Addendum 25: Regulation No. 26

Amendment 2

02 series of amendments - Date of entry into force: 13 December 1996

**UNIFORM PROVISIONS CONCERNING THE APPROVAL OF VEHICLES
WITH REGARD TO THEIR EXTERNAL PROJECTIONS**

Model A

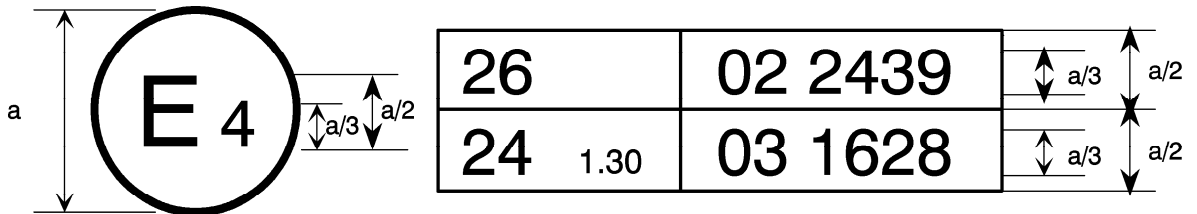
Annex 2, replace by the following:

"Annex 2

ARRANGEMENTS OF APPROVAL MARKS

The above approval mark affixed to a vehicle shows that the vehicle type concerned has been approved in the Netherlands (E4) pursuant to Regulation No. 26 and under approval number 022439. The first two digits of the approval number indicate that, at the time of approval, Regulation No. 26 included the 02 series of amendments.
